**City of Portland, Oregon**  
**Bureau of Development Services**  
**Land Use Services**

**Revised STAFF REPORT AND RECOMMENDATION**  
**TO THE DESIGN COMMISSION**

**CASE FILE:** LU 14-169513 DZM AD &  
 Major Encroachment Review  
 (PC # 13-173133 & DA #13-186674)  
 419 E Burnside

**Floor Plan - First Floor**

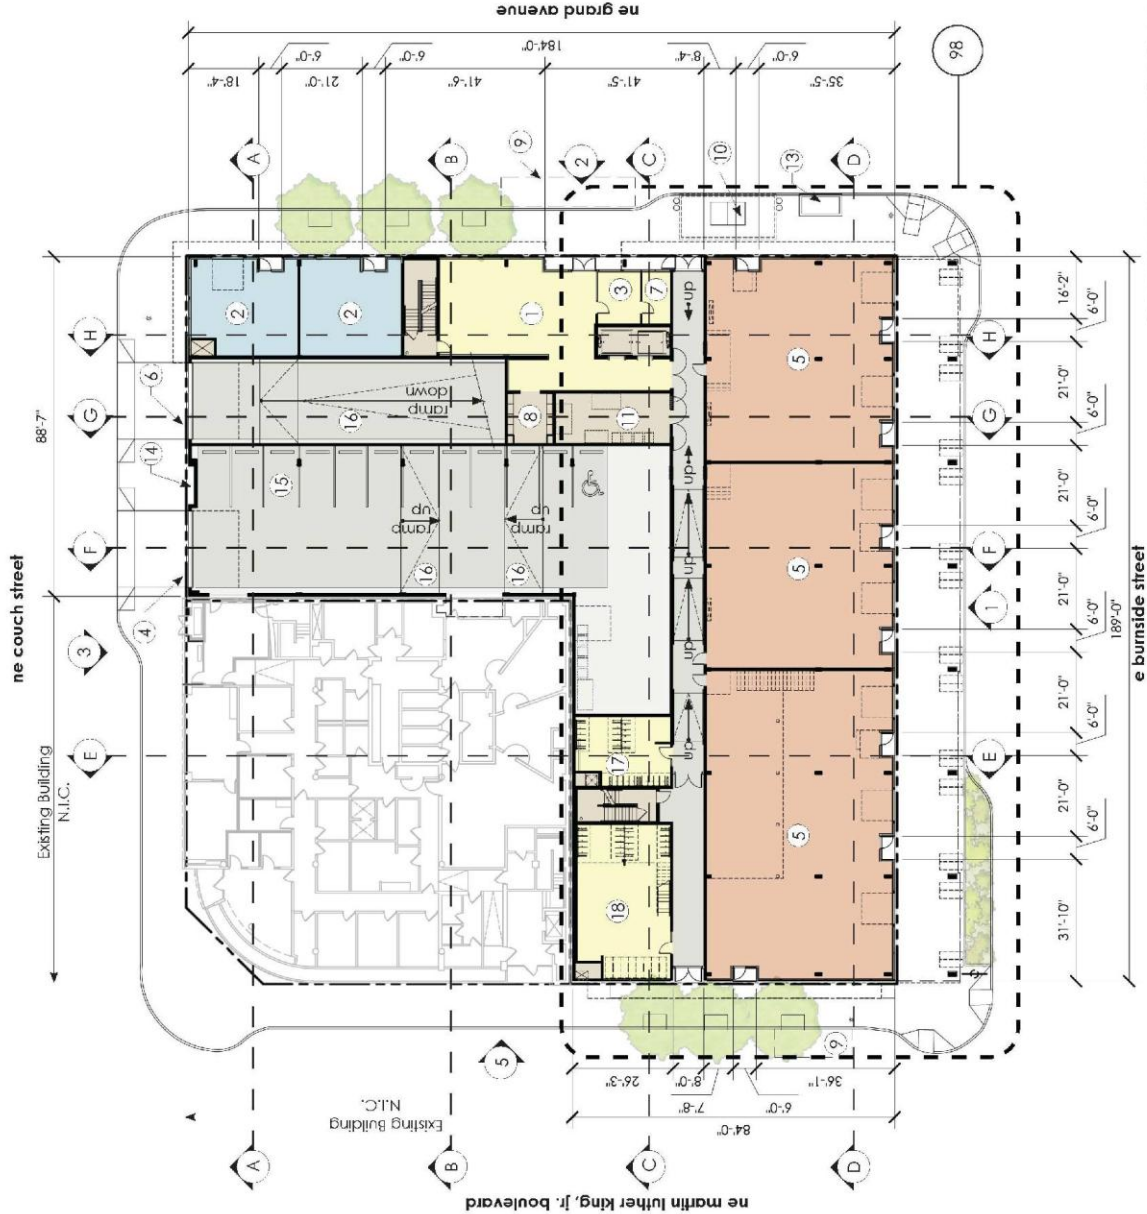
1. Relocate residential entrance from E Burnside Street to NE Grand Avenue.
2. Relocate vehicular garage entrances to NE Couch Street. Maintain two separate garage entrances for residents and CCC secure program.
3. Provide full block arcade along E Burnside Street.
4. Provide larger and continuous commercial/retail spaces along E Burnside Street.
5. Relocate bicycle room from NE Grand Avenue to NE MLK Boulevard.
6. Reconfigure E Burnside public storm water facility to allow it to be entirely outside of arcade footprint.
7. Extend proposed bulb-out at the intersection of E Burnside Street and NE Grand Avenue to the west.

- A brief summary of changes between the previous concept from DR No. 1 and the current design proposal (in no order):
1. Relocate 'gasket' element from E Burnside Street to NE Grand Avenue.
  2. Provide full block arcade along E Burnside Street.
  3. Simplified color scheme - eliminate one shade of grey (now a three-color palette); change primary cladding color from dark grey to white.
  4. Add horizontal box rib metal cladding above and below upper floor windows.
  5. Add horizontal box rib metal cladding at recessed deck walls.
  6. Adjust ground floor to have regular and repeating articulation.
  7. Adjust color of rooftop mechanical screening.
  8. Add diagonal bracing at sixth floor deck locations.

Exterior Elevation - East (NE Grand Avenue)

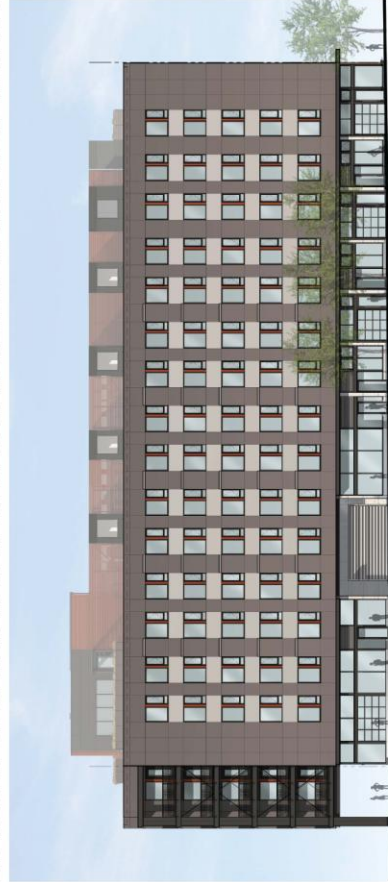
A brief summary of changes between the previous concept from DR No. 1 and the current design proposal (in no order):

1. Relocate "gasket" element from E Burnside Street to mid block along NE Grand Avenue.
2. Relocate vehicular garage entrance from NE Grand Avenue to NE Couch Street.
3. Simplified color scheme - eliminate one shade of grey (now a three-color palette); change primary cladding color from dark grey to white.
4. Add windows to northeast corner of building.
5. Add horizontal box rib metal cladding above and below upper floor windows.
6. Add horizontal box rib metal cladding at recessed deck walls.
7. Adjust ground floor to have regular and repeating articulation.
8. Adjust color of rooftop mechanical screening.
9. Add diagonal bracing at sixth floor deck locations.
